TECHNICAL SERVICE BULLETIN

TSB C-GN-SP-0049 REV1

Date: June 27, 2024
To: All Service, Parts Managers, Sales, Distribution, and Sales Representatives
From: Technical Services Department
Subject: **REVISION: Daikin FIT, Amana® Brand S-series, and Goodman SD Software Update**

Step 1:

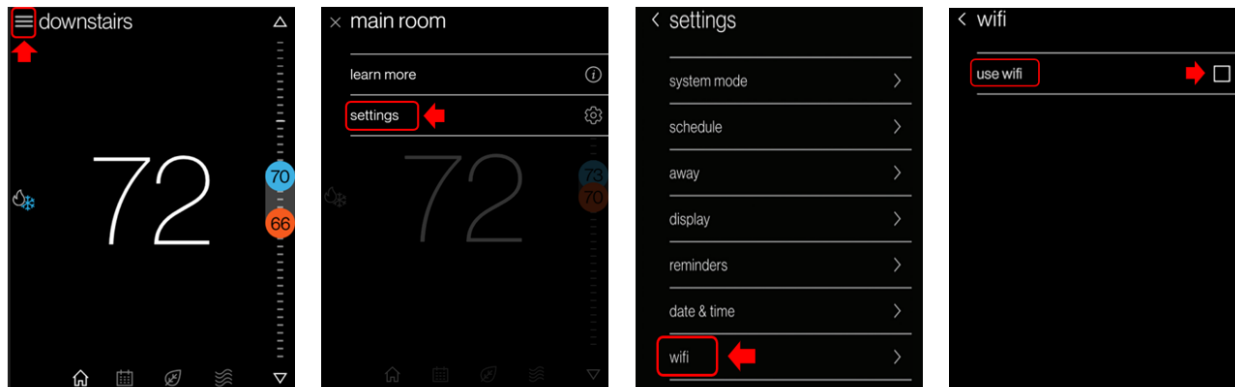
For all Daikin, Amana & Goodman brands replace the outdoor service printed circuit board (PCB) see **Table 3** for the correct Service Replacement PCB part number. If the homeowner has a **Goodman GTST connected thermostat (GTST-CW-WH-A)** Step 2 is not required to be completed.
